## Technical Note

Project	317 Finchley Road
Title	Planning Note to Support S73 Application
Ref.	240
Rev.	C
Date	05.04.24

The purpose of this Technical Note is to provide technical guidance regarding a material amendment to the consented scheme (Planning Ref. 2016/2910/P) The proposal looks to replace the following drawings:

Fig. 18 Proposed section B Rev J with additional overrun shown in green.

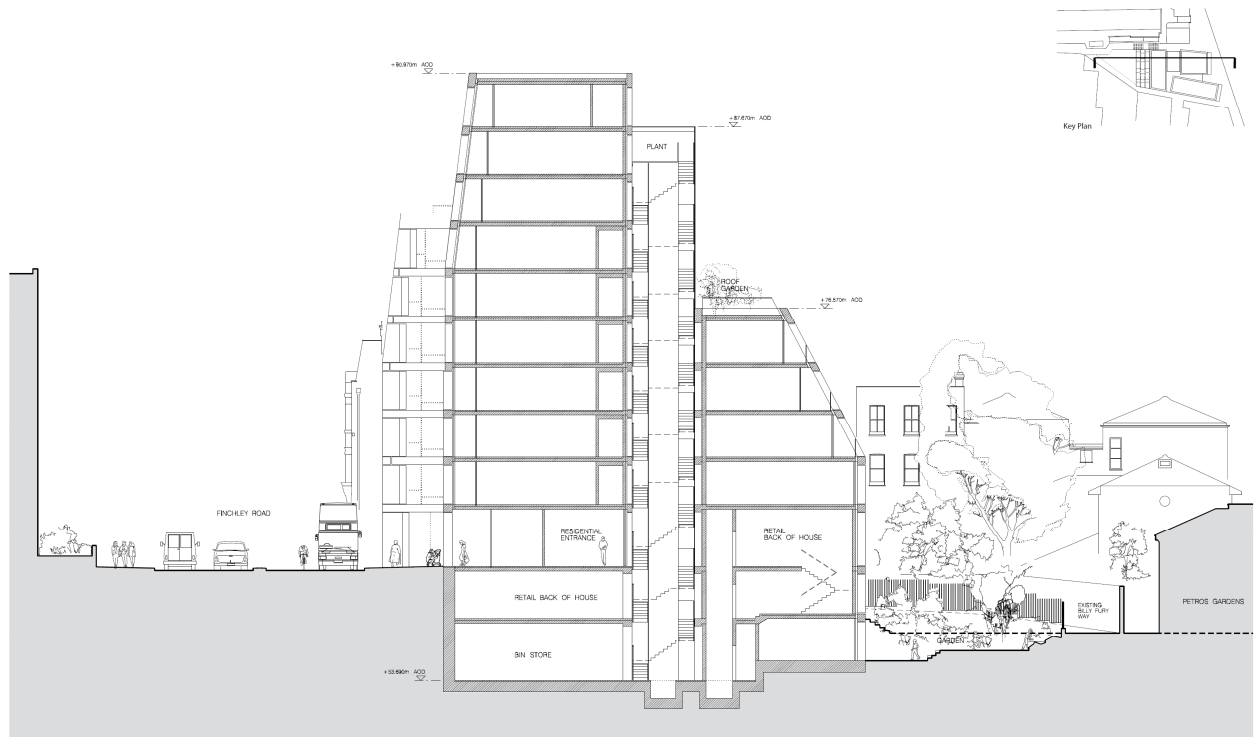
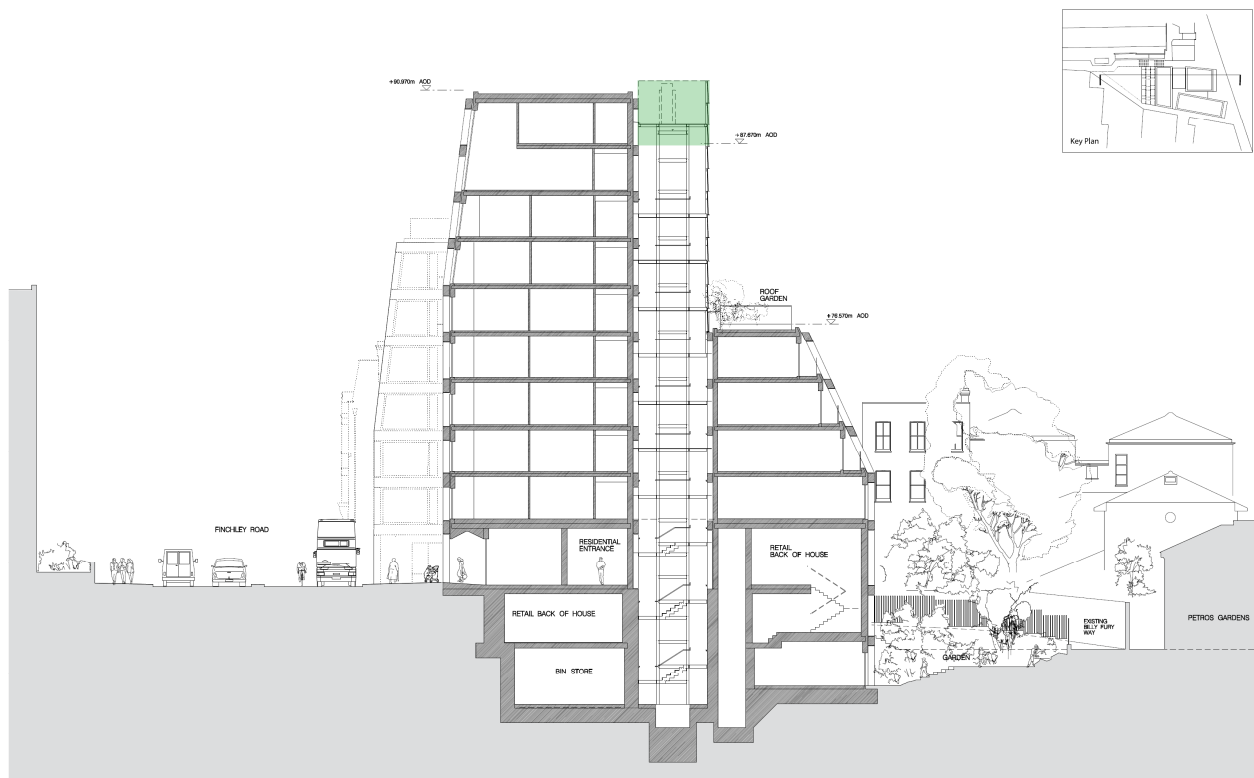
8.1 As a result of upgrades to the building to meet current fire safety requirements under Approved Document B, the lift and stair core now requires an additional mechanically vented smoke shaft and firefighting lift. Both additions require a backup energy supply to maintain operation in the event of a fire. The backup energy supply will be a generator which must be located with adequate ventilation and proximity to the stair core. As such, it is proposed that the central core is increased in height to provide an overrun and effective visual screening to new rooftop plant to avoid visibility from the neighbouring Conservation Area and key sightlines along Finchley Road. The overrun has been minimised in height to have the minimum impact possible.

8.2 In parallel with the addition of a backup energy supply, the firefighting lift specification requires additional height to be added for a lift overrun when compared to the planning approved scheme. This upgrade to the specification is a result of upgrades to the lift to meet the relevant fire safety requirements under Approved Document B.

8.3 A further effect of upgrades to meet the relevant fire safety requirements under Approved Document B has been an adjustment in the flat entrance locations due to the inclusion of a new fire lobby between the stair and flat entrances. This has resulted in an adjustment to the location of unit 21 and unit 22 which were previously both accessed from the seventh floor. This has been changed to unit 21 from seventh floor and unit 22 from eighth floor. Both require level access in line with Approved Document M which has resulted in an additional level for the lift to serve, increasing the height of the overrun.

8.3 In conclusion, the adjustments have been made due to upgrades to the building to meet new fire safety requirements under Approved Document B which since the original approval in 2016 have been upgraded significantly. The design team have worked closely with fire engineers to ensure that all regulations are met whilst ensuring the proposed new design still adheres to the original approval's design concept. In this regard, the central stair core still visually reads as a separate element to the 3 structural stone blocks located to each elevation.

Fig. 19 Proposed access arrangements showing amenity location and new flat layouts adjusted with new fire lobbies between the stair and flat entrances.

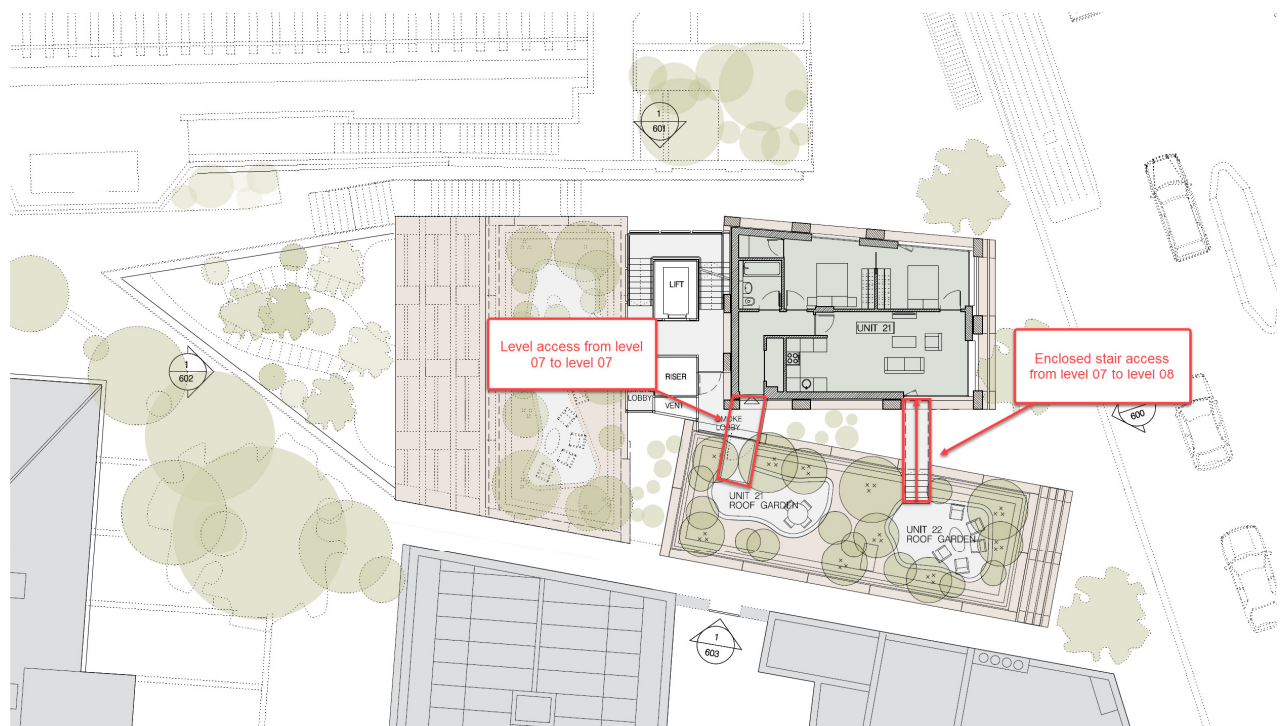
9.1 Due to upgrades to the building to meet the relevant fire safety requirements under Approved Document B, the central core arrangement has been adjusted to include a fire lobby between the stair and flat entrances. This has resulted in an adjustment to the location of unit 21 and unit 22 which were previously both accessed from the seventh floor. This has been changed to unit 21 from seventh floor and unit 22 from eighth floor.

9.2 As a result of the change in access level, the previous arrangement for private amenity space on the block B roof (both accessed from seventh floor level) is proposed to be altered to allow unit 21 access from the seventh floor level and unit 22 from the eighth floor level, stepping down a secure and enclosed staircase to the roof garden level. The design has been proposed to enclose the stair in a lightweight mesh to avoid the effects of vertigo when accessing amenity space from unit 22.

Fig. 23 Proposed ground floor plan Rev N.

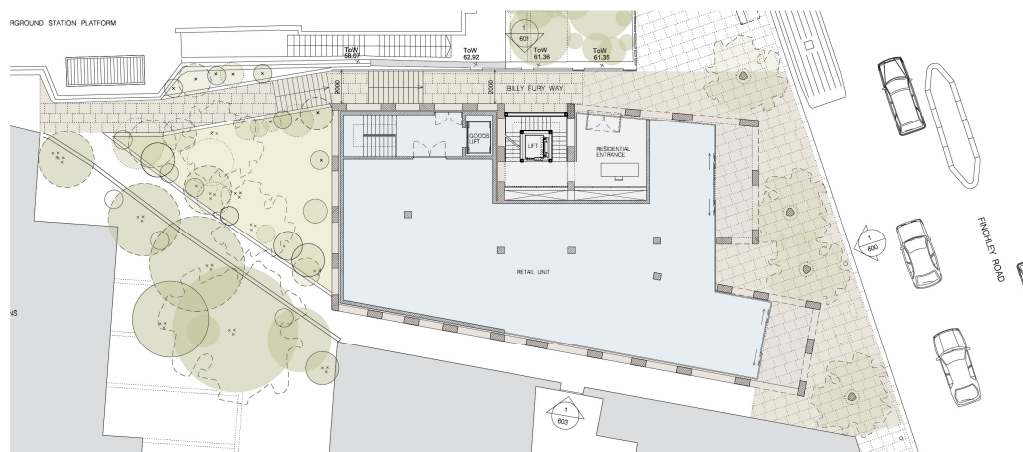
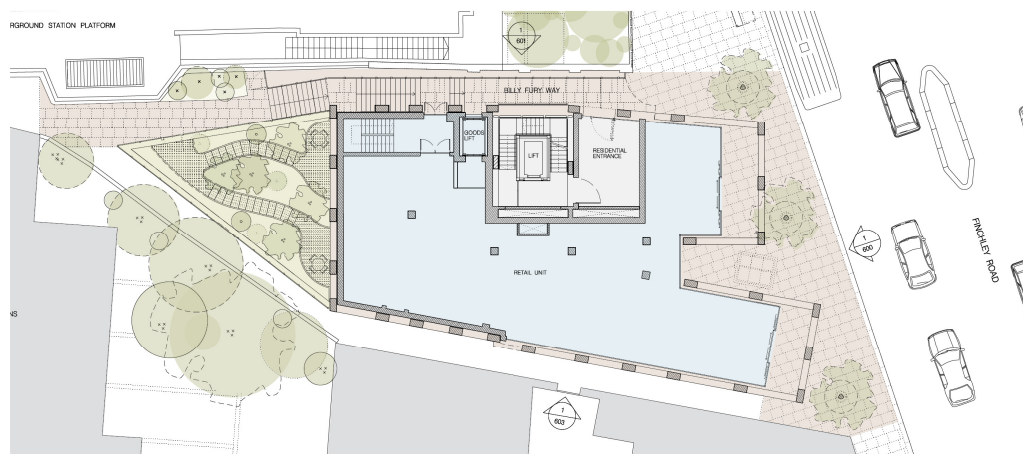
11.1 New fire regulation changes post planning approval and commencement on site meant external walls have had to get thicker and similarly fire rated walls introduced around the lift core and service risers which were previously external. Changes requested by planners to internal layouts for better daylight to habitable rooms meant rooms were swapped about and to ensure they met GLA guidelines the overall layout changed which affected the position of some stone columns. All adjustments are within the site red line boundary and are proposed to not materially affect the massing when studied from the streetscape or townscape scale.

11.2 An adjustment to the ground floor glazing line is also proposed to allow for a new smoke vent from basement level. The cut back will follow the line of the blocks above, reinforcing the approved design's depth and variation between blocks.
